Access Compliance Report

Public Rights-of-Way

| Intersection ID: 14873 | Main Street: BRIAR_CREEK_RD | Cross Street: E_INDEPENDENCE/BRIAR_CREEK_RA | Location: NE |
| ADA ID: BDC930508DD3 | Ramp Type: PerpDiag | Initial Pass/Fail: Fail | Overall Compliance: No |

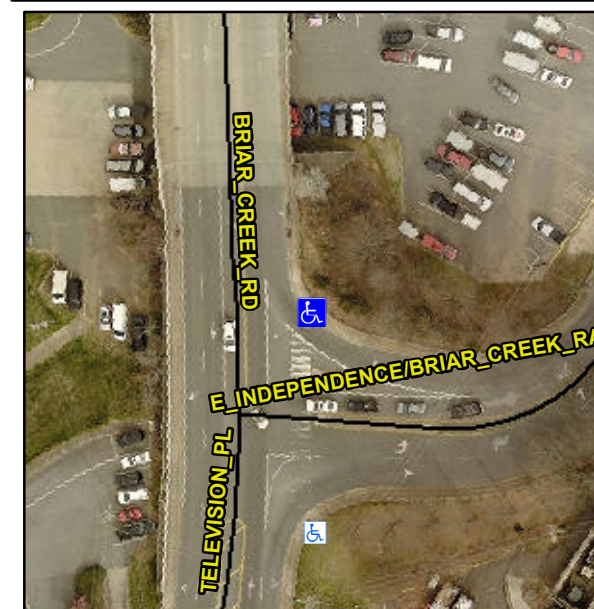
Not Found, R304.5.1, R304.2.2

| Compliance | Description | Data | Compliance | Description | Data |
|------------|-----------------------|------|------------|-----------------------------|-------|
| N/A | Ramp Length (in) | 48.0 | No | Ramp Slope (%) | 9.0 |
| No | Ramp Width (in) | 45.0 | Yes | Ramp XSlope (%) | 0.7 |

Remove & Replace Curb Ramp With Two New Directional Ramps or Equivalent.
